TSB061615

## TECHNICAL SERVICE BULLETIN

**SUBJECT:** Improved Ground Speed/Foot Count Sensor

### MODELS BR and SR Series Harvesters

**Figure 1—Ground speed sensor on BR models.**

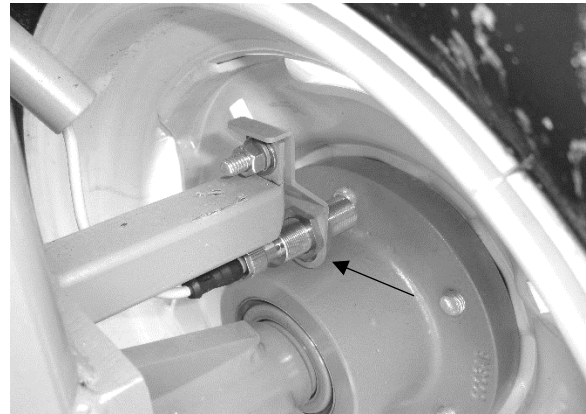
A new, more accurate and durable system to determine ground speed and foot count is available. If the foot count on your Magnum counter is inaccurate or inconsistent, consider upgrading the ground speed sensor.

4. Attach the new mounting bracket to the existing reed switch mounting fixture using the provided fastener. See **Figure 1** (BR models) or **Figure 2** (SR models). Do not tighten the bracket fastener yet.

5. Install the sensor into the bracket. On BR models, carefully adjust the sensor mounting bracket so the tip of the sensor is aligned with the wheel studs protruding through the hub. See **Figure 1**. On SR models adjust the bracket so the tip of the sensor is aligned with the rounded tip of the hub casting as shown in **Figure 2**.

6. Tighten the bracket fastener.
7. Adjust the sensor inward or outward as necessary to obtain 1/8 to 3/16 in. (3.2-4.8 mm) air gap between the tip of the sensor and the wheel studs (BR) or hub casting (SR). Securely tighten the sensor nuts while making sure the air gap remains as specified.
